RE: Response to Agency Submissions for Rix's Creek Continuation of Mining Project

The following outlines additional information and clarification to address the New South Wales (NSW) Environment Protection Authority (EPA), Singleton City Council and NSW Health submissions relating to the Air Quality Assessment (AQA) for the Rix's Creek Continuation of Mining Project (the Project) (**Todoroski Air Sciences, 2015**).

Figure 2: Sensitive receptor locations assessed in the AQA

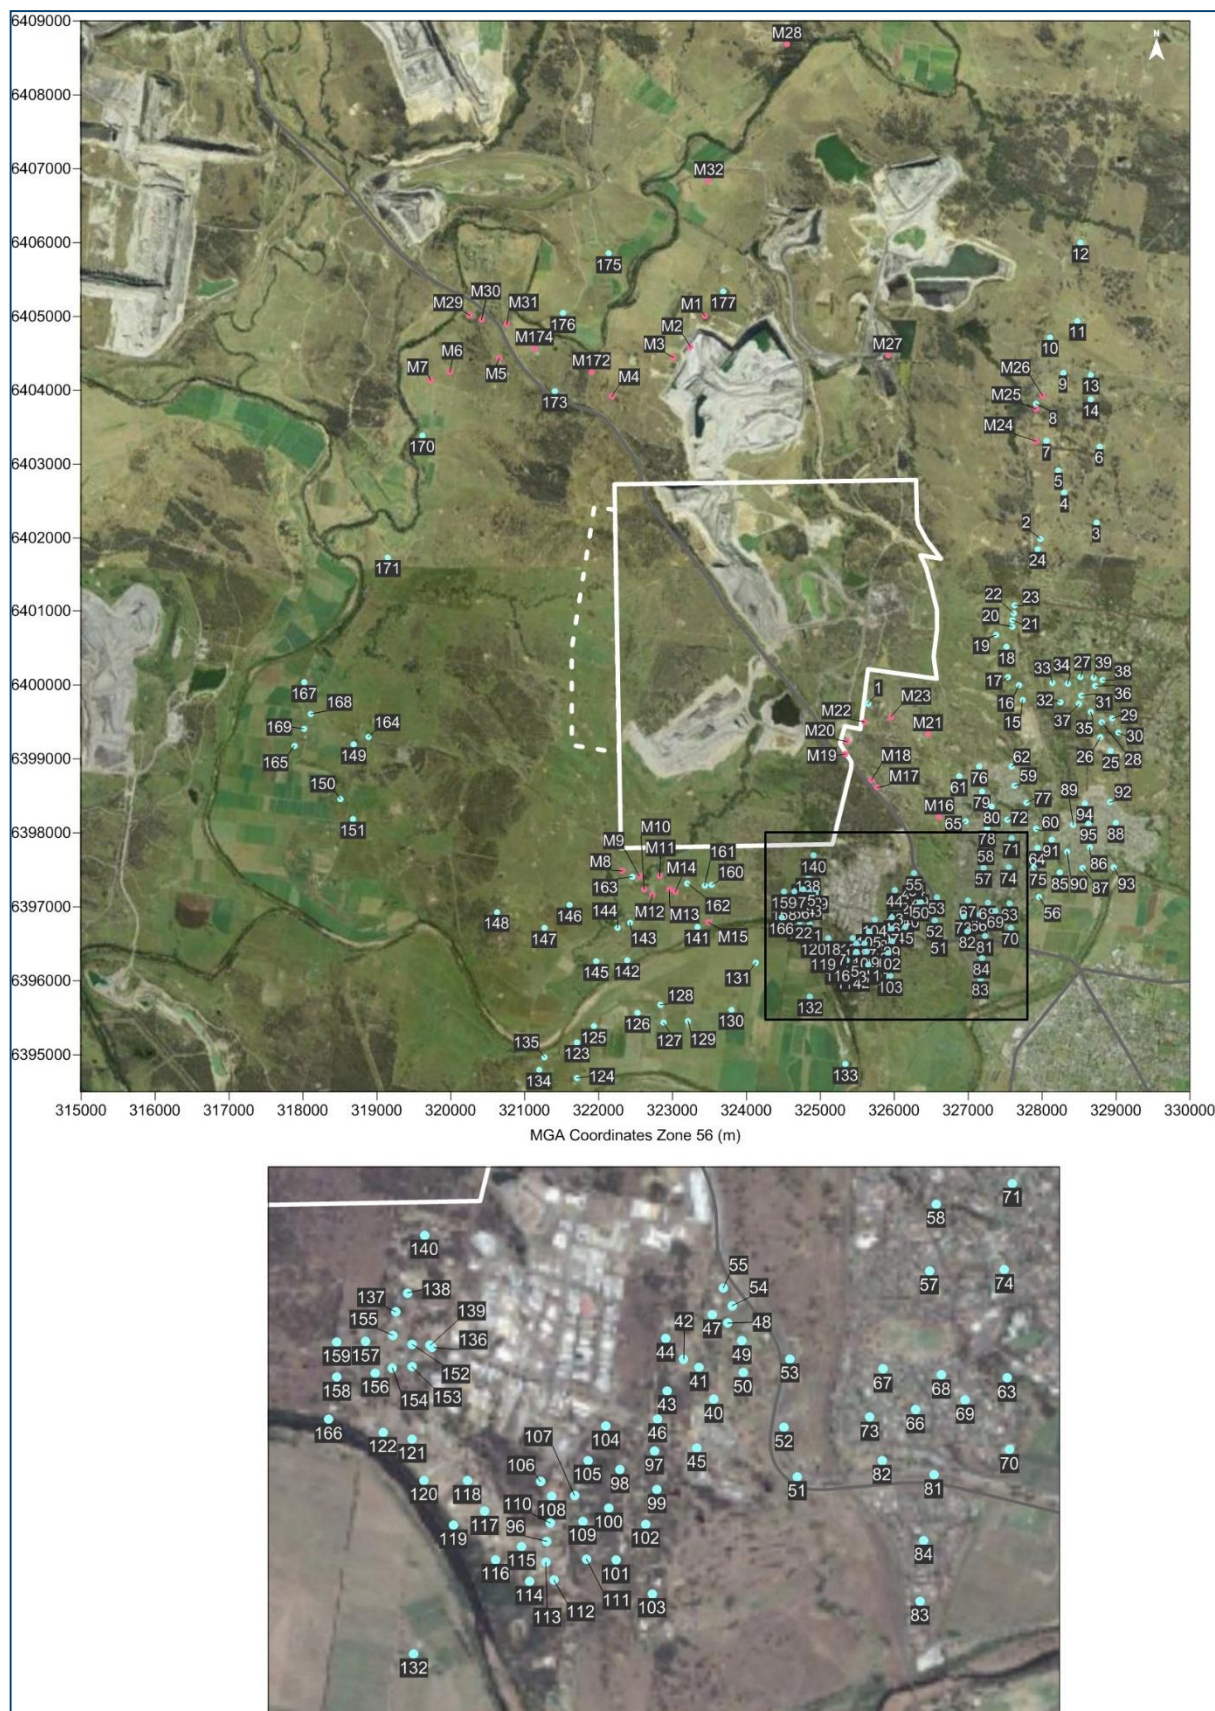
A clarification of the AQA has been identified with regards to the sensitive receptor locations presented in Appendix B of the AQA. In Figure B-1 of Appendix B of the AQA, the mine owned receptors labelled as M5 to M33 are incorrect and should be labelled from M4 to M32.

We also note that the receptor labelling in the figures of Section 11 of the EIS are also incorrect.

Figure 3: Predicted 24-hour average PM₁₀ concentrations for Receptor 45 in Year 2017 and 2020

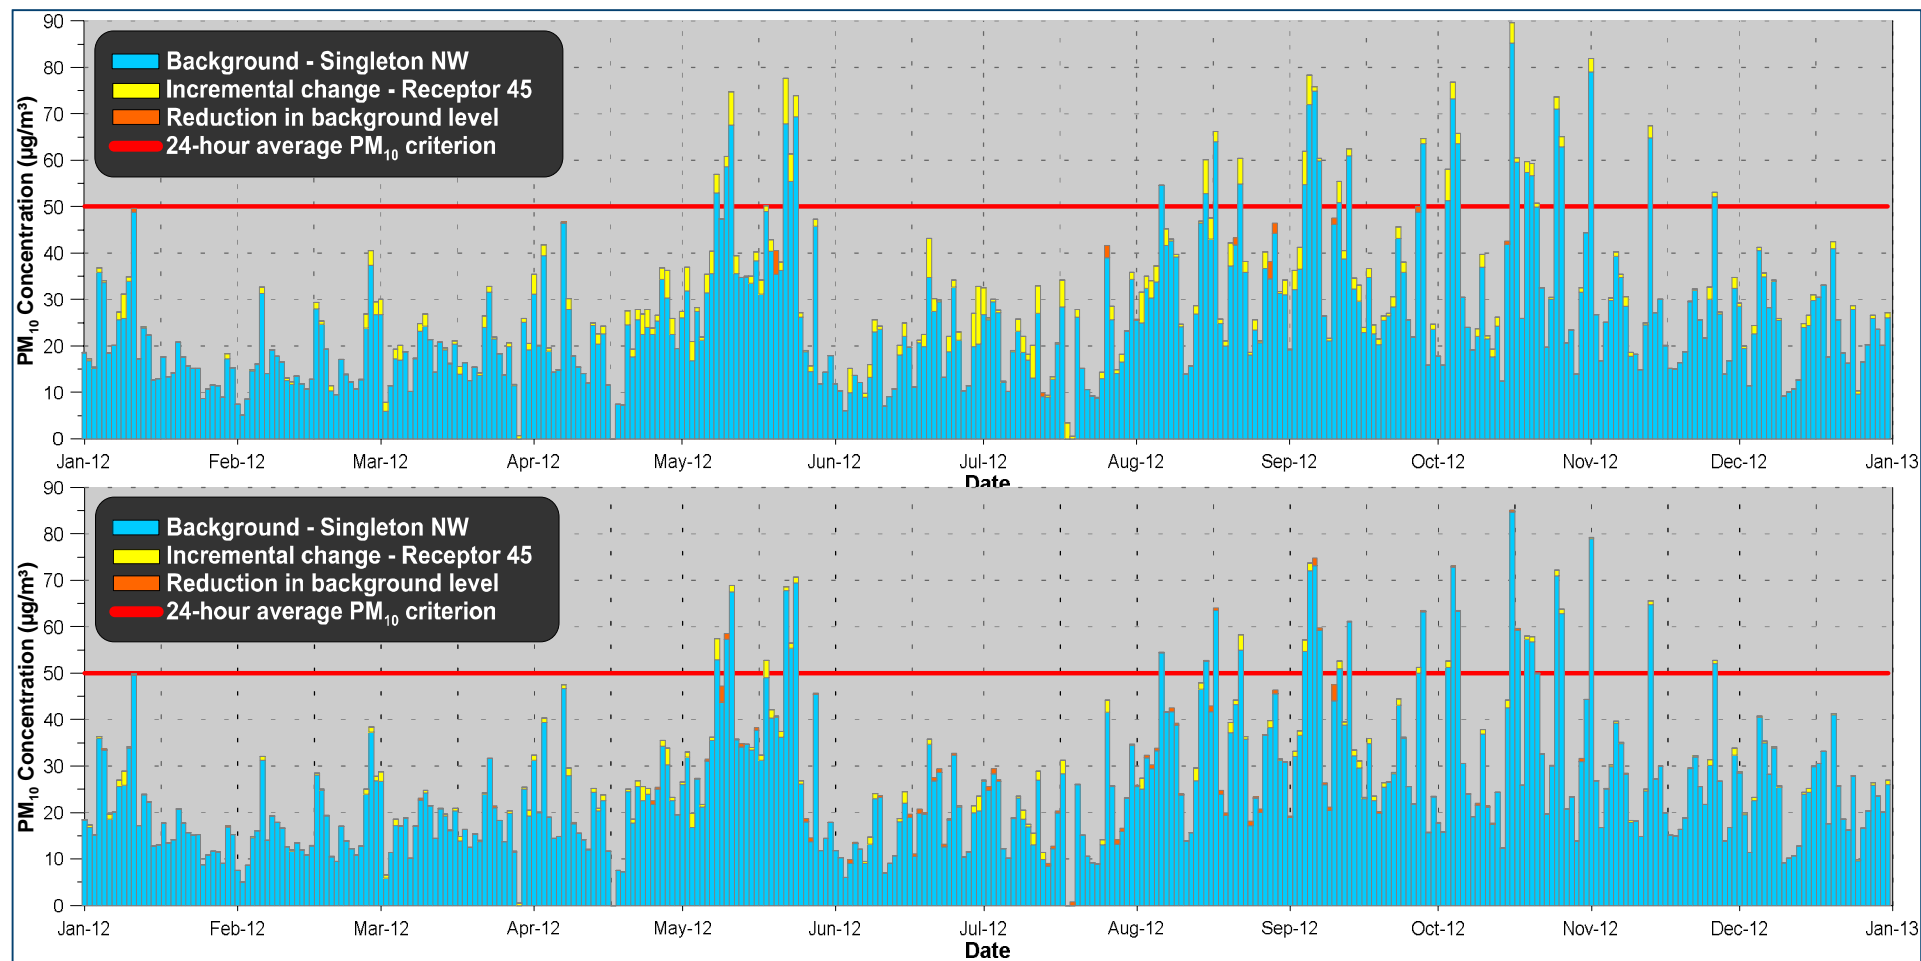
“Country Acres Caravan Park at 58 Maison Dieu Road lies to the south-west of the proposed pit expansion and within 500 metres. It does not appear to have been assessed as a receptor. Maitland Diesel Service is located on Rix’s Creek Lane and also does not appear to have been assessed as a receptor. The EPA requires the potential impact at these receptors to be assessed.”

A contemporaneous PM₁₀ assessment per the NSW EPA Approved Methods has been performed for the Country Acres Caravan Park (Receptor 45) to determine the extent of potential impacts at this location. A summary of the findings of the contemporaneous assessment is presented in **Table 6**. A time series plot of the 24-hour average PM₁₀ concentrations is presented in **Figure 3** and **Figure 4**.

The results indicate that the potential cumulative PM₁₀ impact which could arise at this location may be between 1 to 4 additional days of impact. A comparison of these predictions with those predicted for Receptor 140 and Receptor 61, which are located closer to the Project than the Country Acres Caravan Park, show that the predicted number of impact days would be lower in only some years, indicating that the predicted levels for the surrounding area would be of a similar magnitude.

The time-series plots presented in **Figure 3** and **Figure 4** indicate that **Table 6** is not an optimal indicator of potential impact. The plots show a general decline in overall impacts over time.

Figure 6: Incremental 24-hour average PM₁₀, existing mine 2012 (blue) vs. Project worst case year 2023 (faded yellow) vs. Project reduced schedule year 2023 (orange)

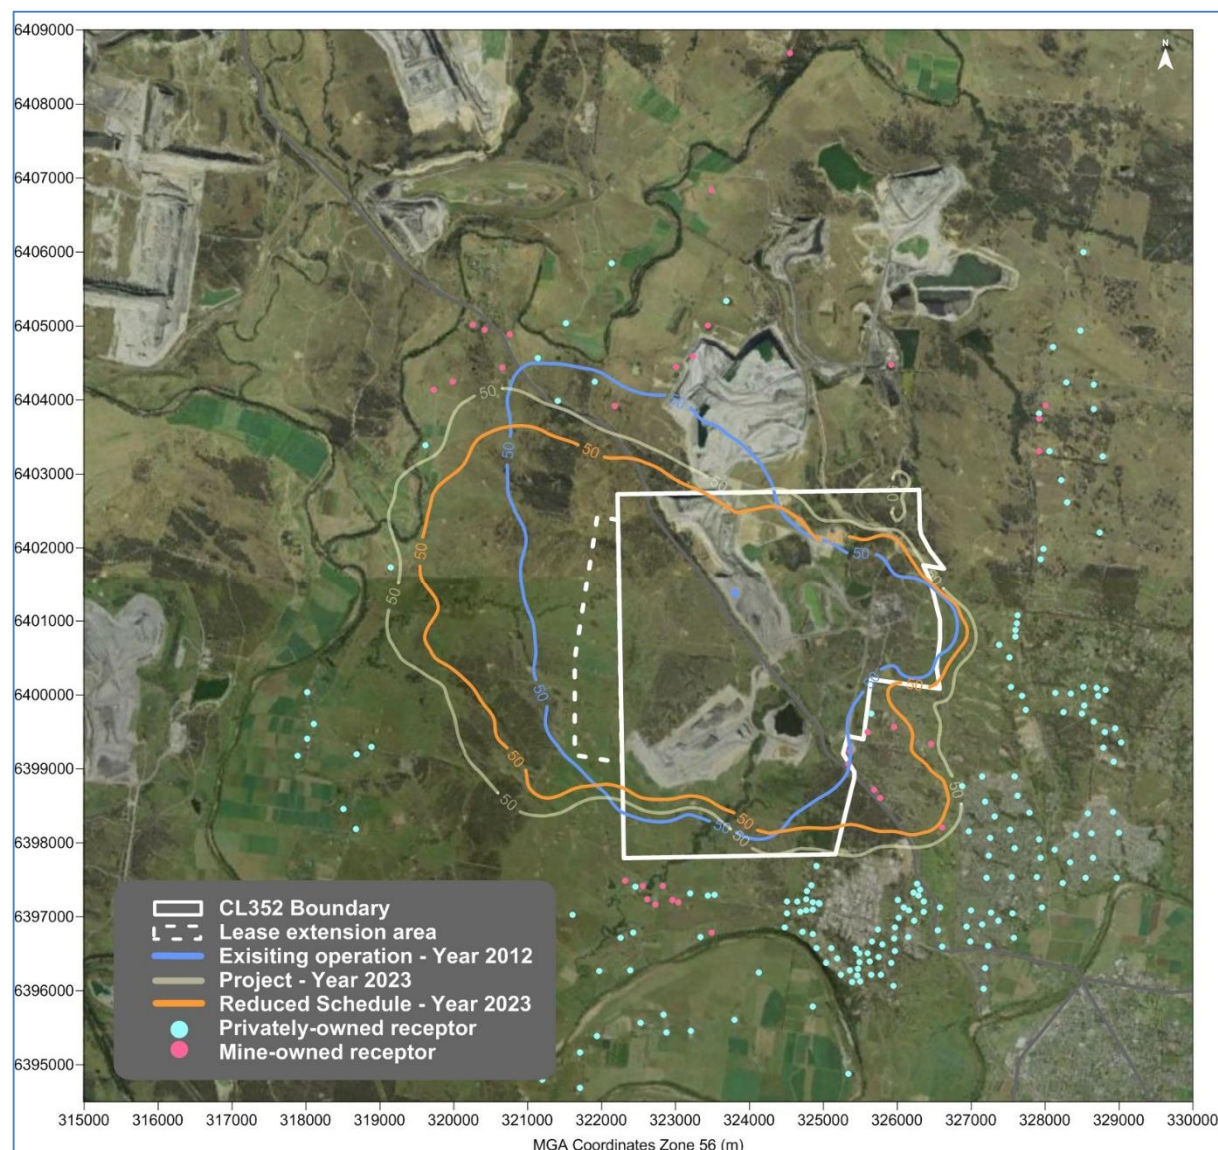
“Council is currently considering a Planning Proposal seeking to rezone land to residential in North Singleton, west of Bridgeman Road and north of Gardner Circuit. While it is acknowledged mining operations are moving away from Singleton it is not clear from the EA the extent of, if any, noise impact on this area having regard to future residential land uses.”

Figure 6 shows that for the worst case year assessed, the impacts from the mine would increase in the area proposed to be subdivided.
